Sherwood Tailings Reclamation Plan

Responses to NRC Comments

Prepared by Washington Department of Health
Environmental Health Programs
Division of Radiation Protection
Waste Management Section

July 2000

FIGURE 1
 TAILINGS COVER ELEVATIONS
 AS OF 10/5/98

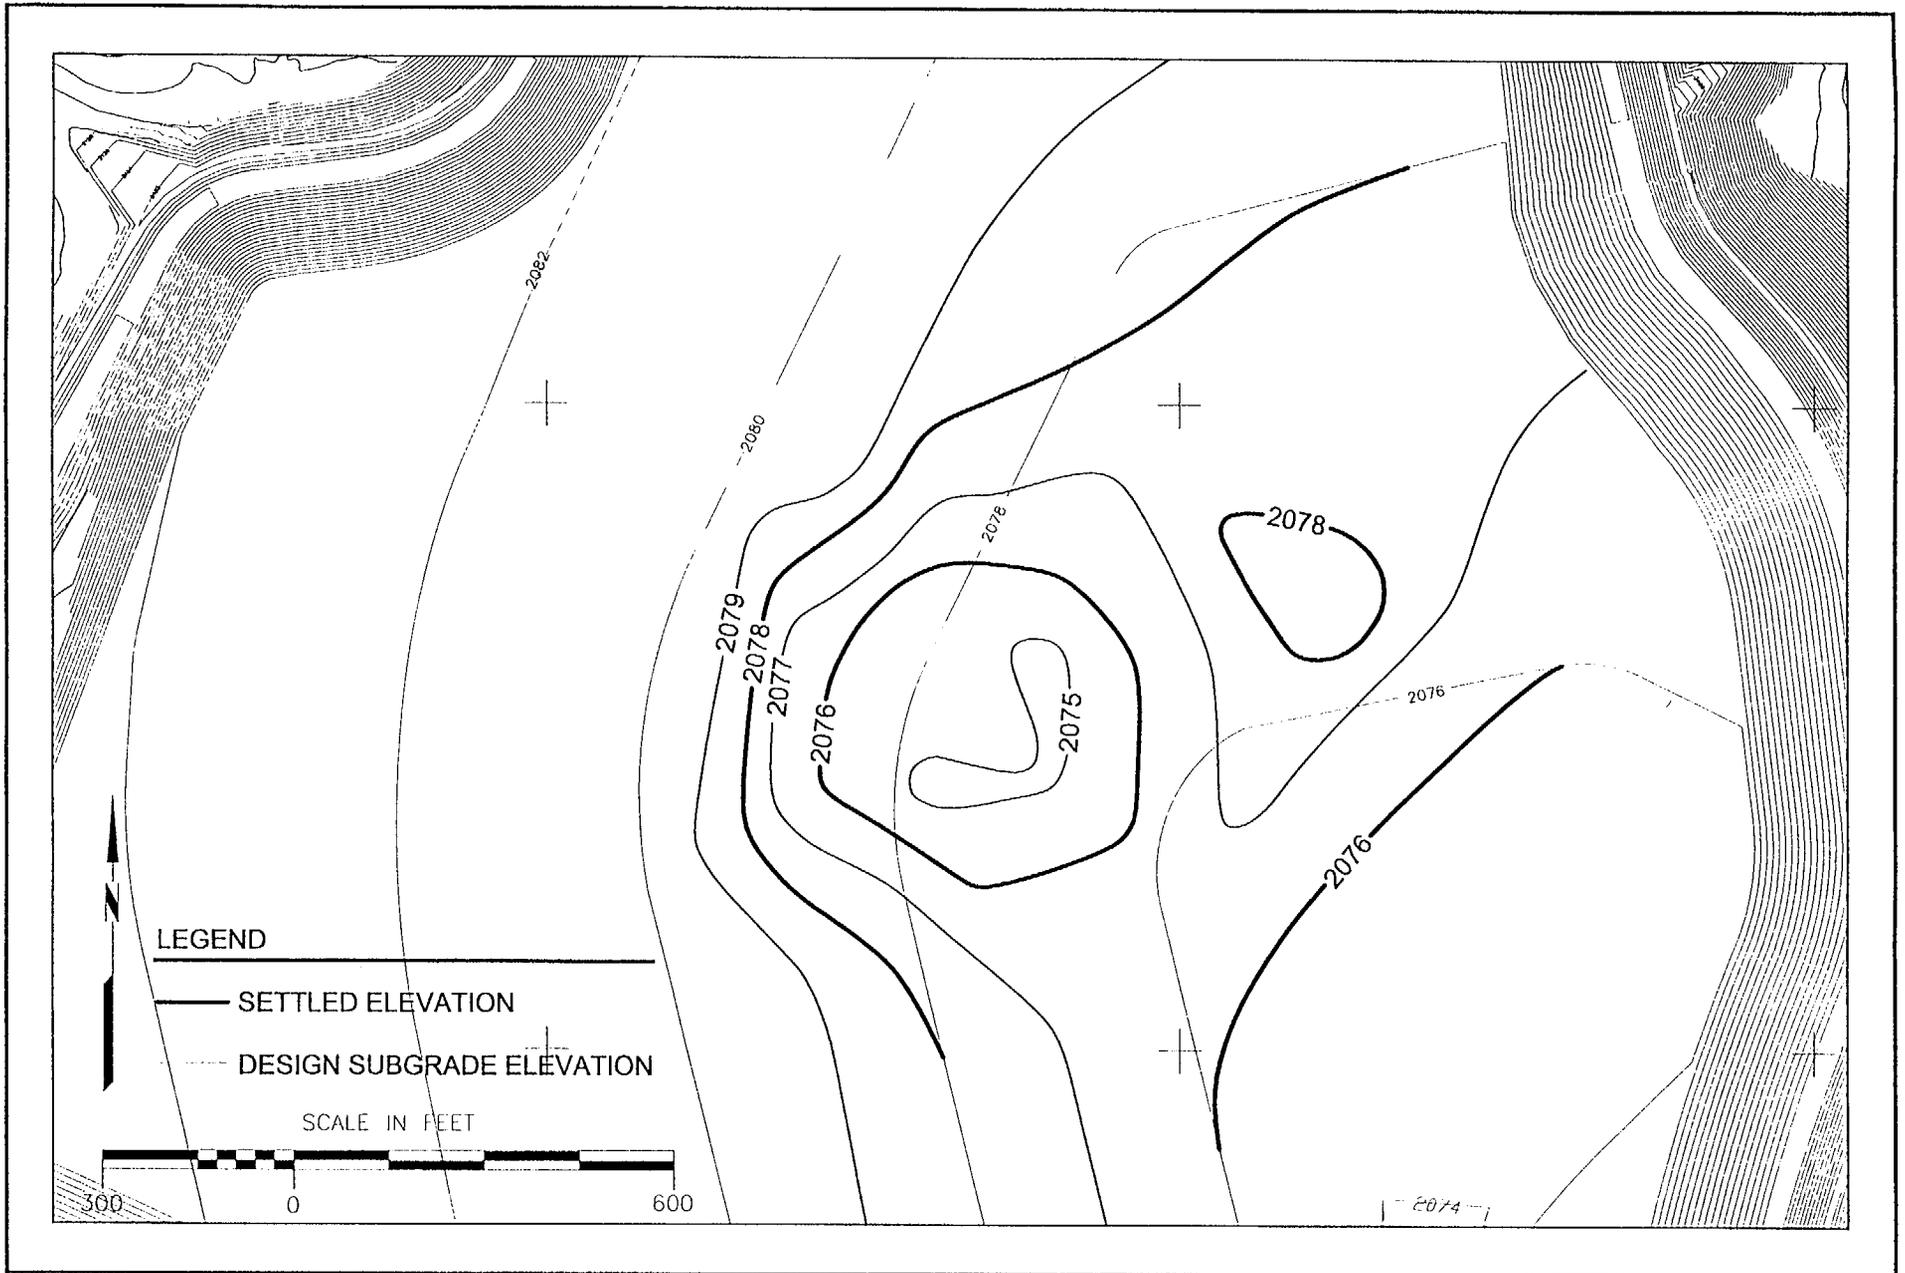
Survey results for areas around and within the settlement area were taken at the end of construction (9/95) and subsequently in 5/5/97 and 10/5/98. The results of the surveys are shown on Table 1. The 10/5/98 configuration is shown on Figure 1.

FIGURE 1
PREDICTED SCOUR ON
IMPOUNDMENT SURFACE

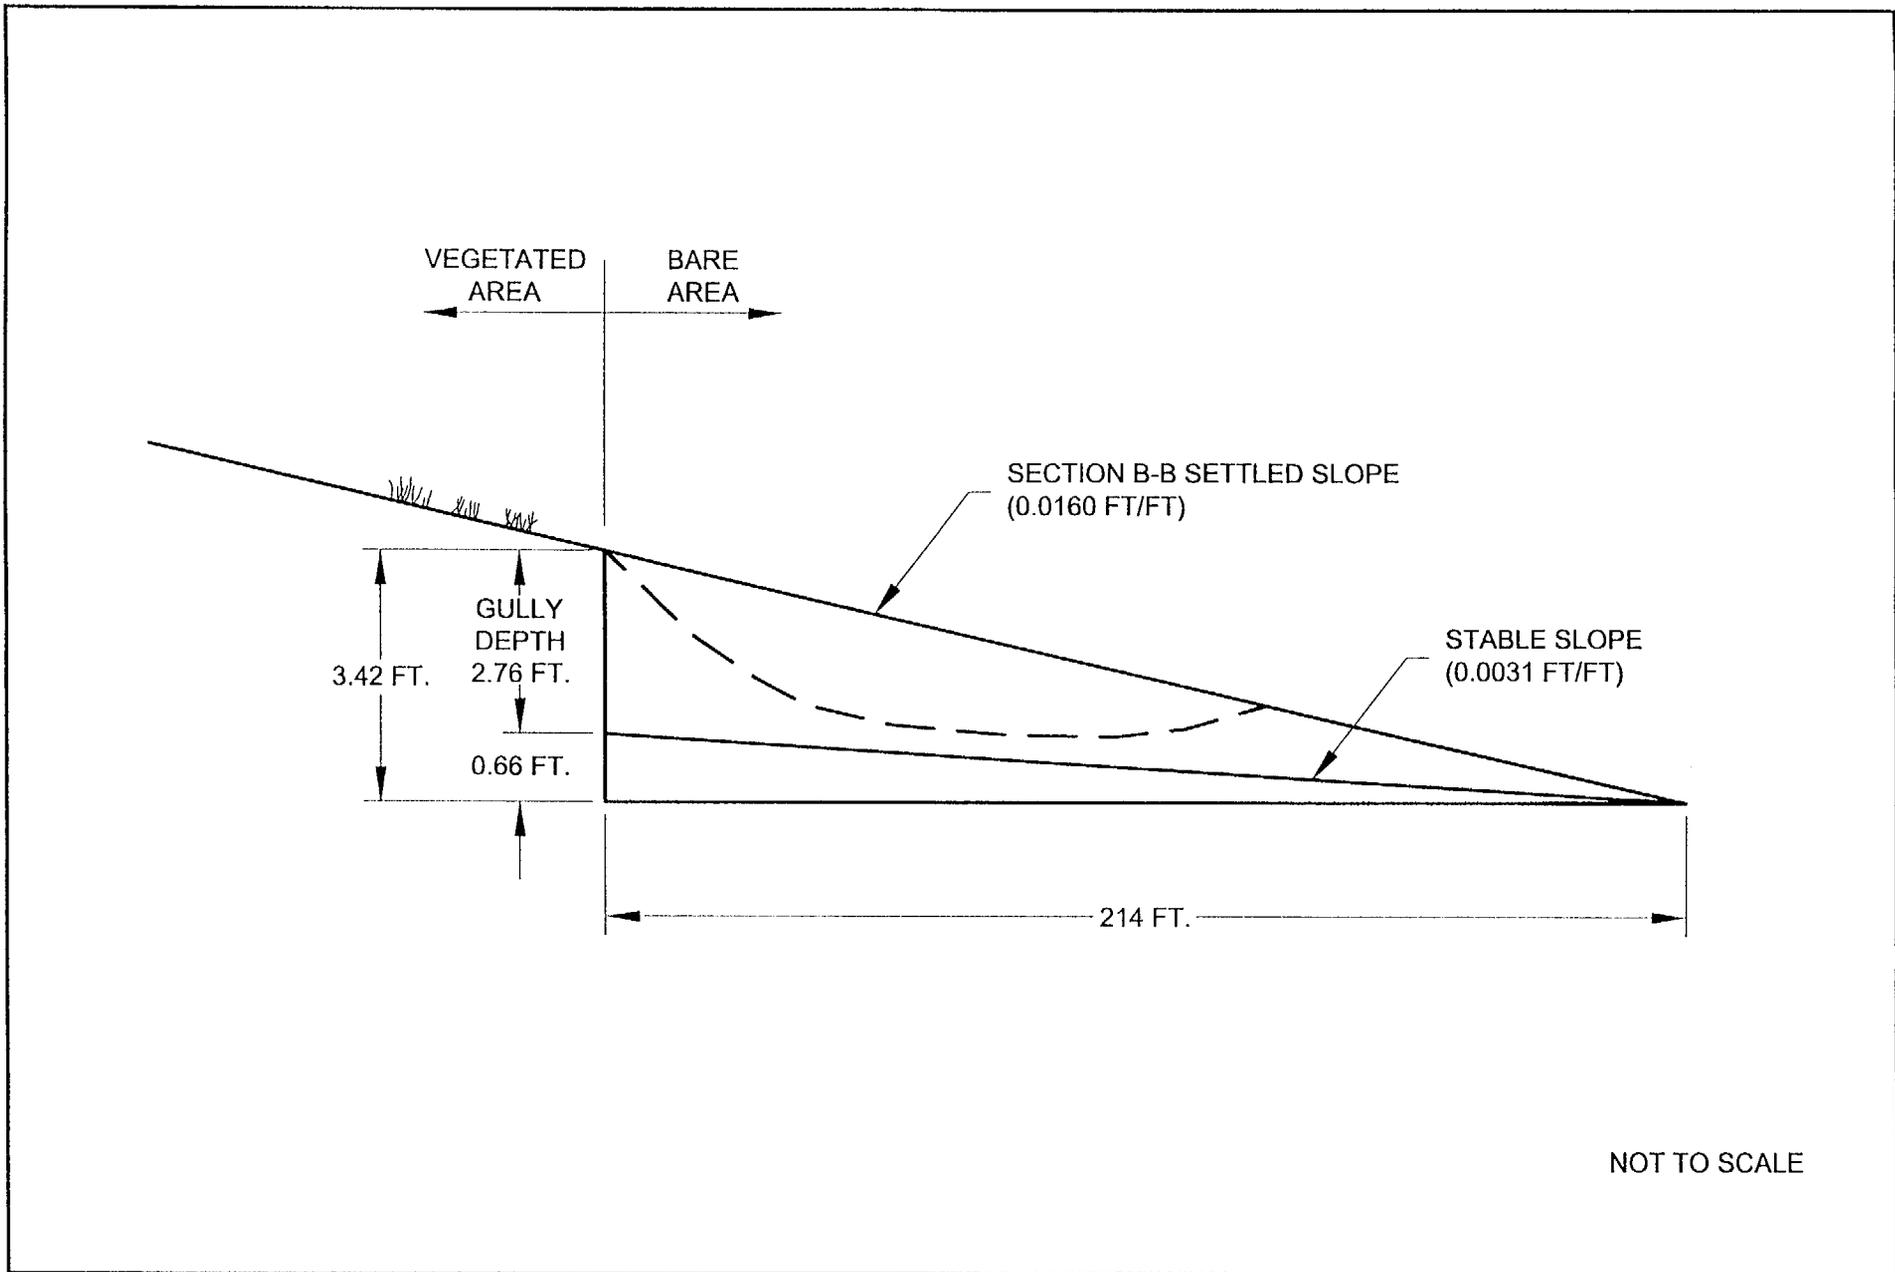
The stable and settled slopes are shown on Figure 1. The stable slope for the bare area was calculated to be 0.0031 ft/ft, which corresponds to a vertical drop of 0.66 feet for the 214-foot slope length. The slope of the impoundment surface for Section B-B was measured to be 0.0160 ft/ft, corresponding to a vertical drop of 3.42 feet. The amount of scour that could potentially occur during the PMF is 2.8 feet.

The analysis shows that under worse case assumptions, a gully approximately 3 feet deep could occur over the surface. This erosion will not however adversely impact the performance of the cover. First, since the cover is 13.6 feet thick (only 12.6 feet was required), removal of a small portion of the total thickness of the cover over a very small area would not cause any change to the overall radon flux from the cover. The area over which the erosion would occur would be so small as to be insignificant relative to the area of the rest of the reclaimed impoundment. In addition, the material removed from the erosion feature would be deposited over another portion of the cover. Therefore the total material covering the tailings would not change. Furthermore, the water content in this area will be greater than the water content assumed for the radon modeling (likely saturated in at least the lower portion of the cover which would eliminate all radon flux from the tailing). Therefore, the flux from this area and the overall average flux from the reclaimed tailing impoundment will be less than 20 pCi/m²/s requirement.

FIGURE 9
 FILTER REGION FOR 18" RIPRAP

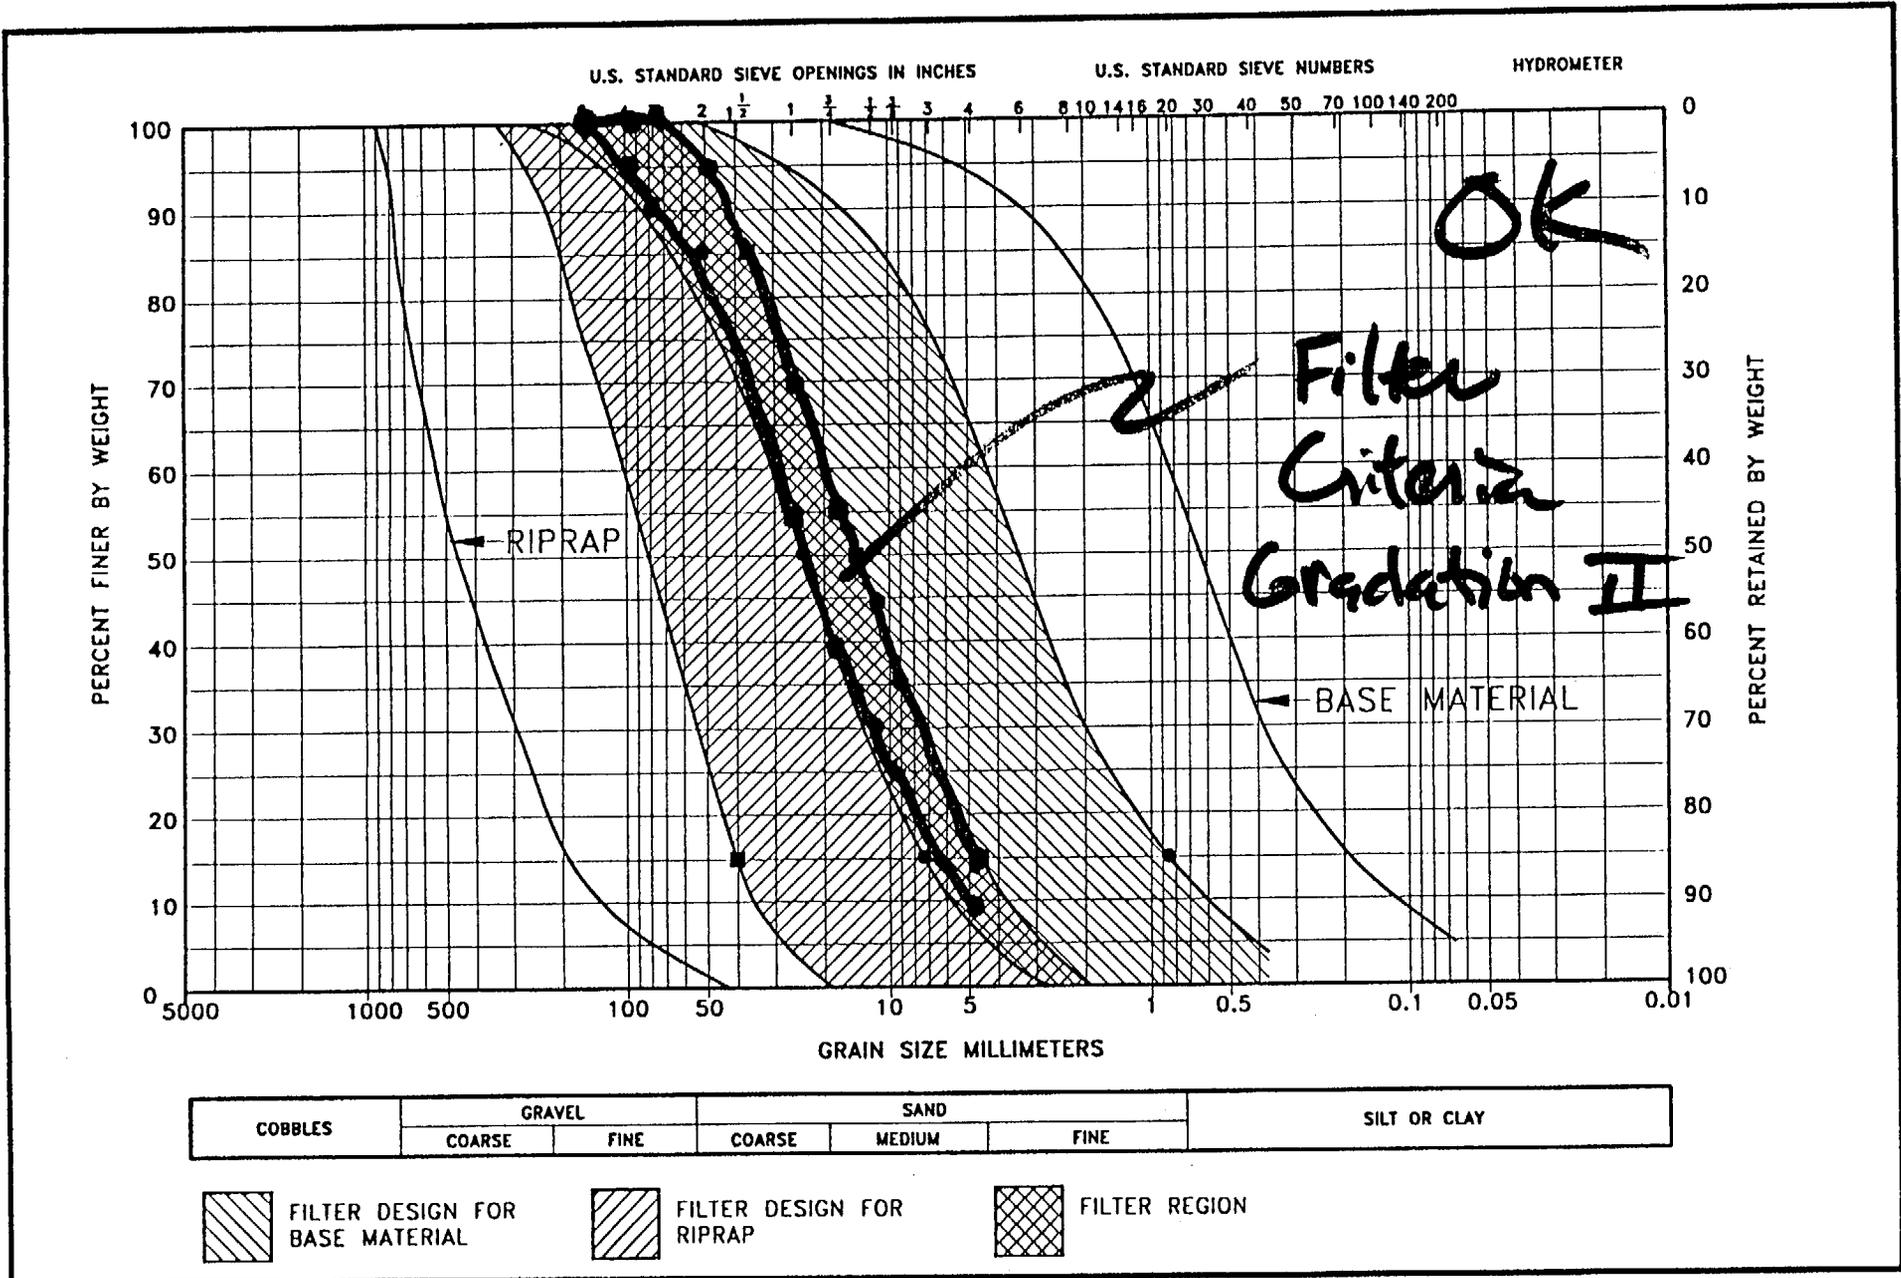
For greater D_{15} sizes on the bottom of the first sheet of Table 2A ~~the D_{85}/D_{15} ratio is D_{85}/D_{15} by the continuation sheet~~ considerably larger than what is called for in typical filter design criteria, i.e., sections 21+14 - 22+48 to 67+42 - 68+71.

Same problem occurs again in the lower portion of the continuation sheet for the embankment but no need to speak of here.

OK on Filter layer functioning to protect sand Subgrade assuming d_{85} of sand typically No 10 sieve

FIGURE 5
SEISMIC HAZARD CURVE

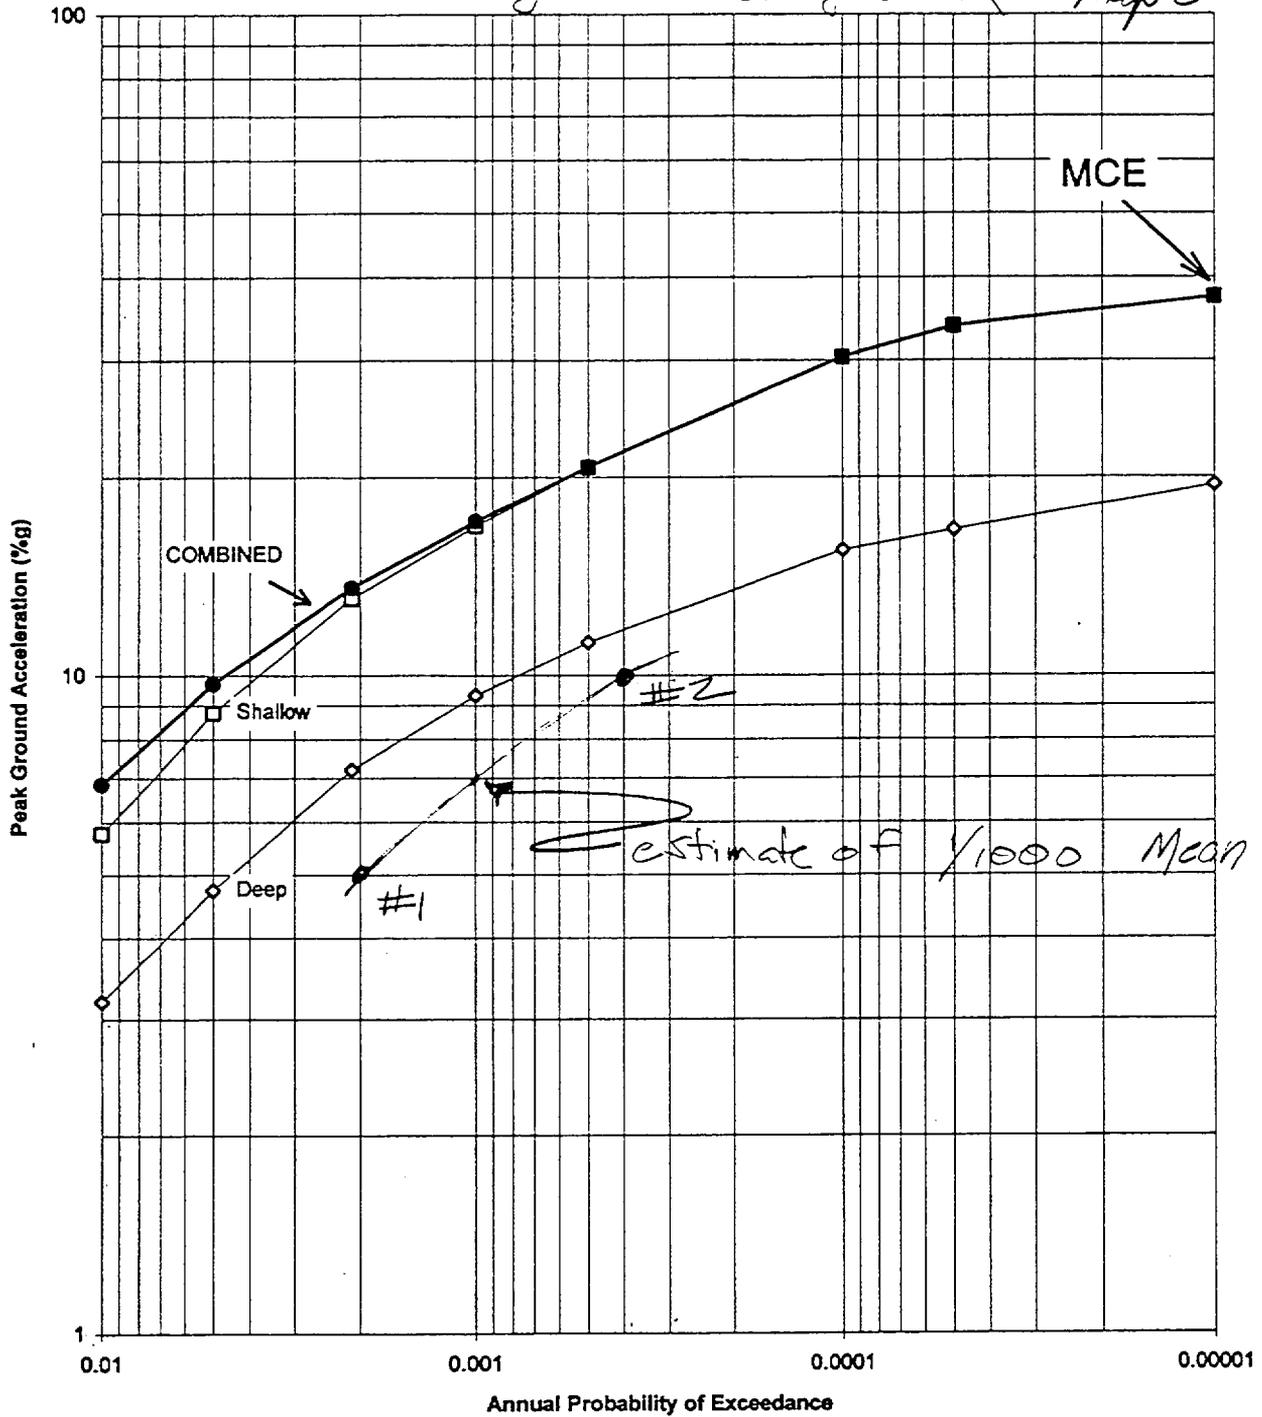
#1 0.3 sec spectral accel.
divided by 2.5 to give
Ap from 1991 NEHRP at
10% chance of exceed.
in 50 years ~ 475 yr
Map 5

#2 0.3 sec spectral acceleration
at 10% chance of exceedance
in 250 years ~ 2475 year event

CONCLUDE : LIQUEFACTION POSSIBLE - AS A CONSEQUENCE ESTIMATE PROBABLE
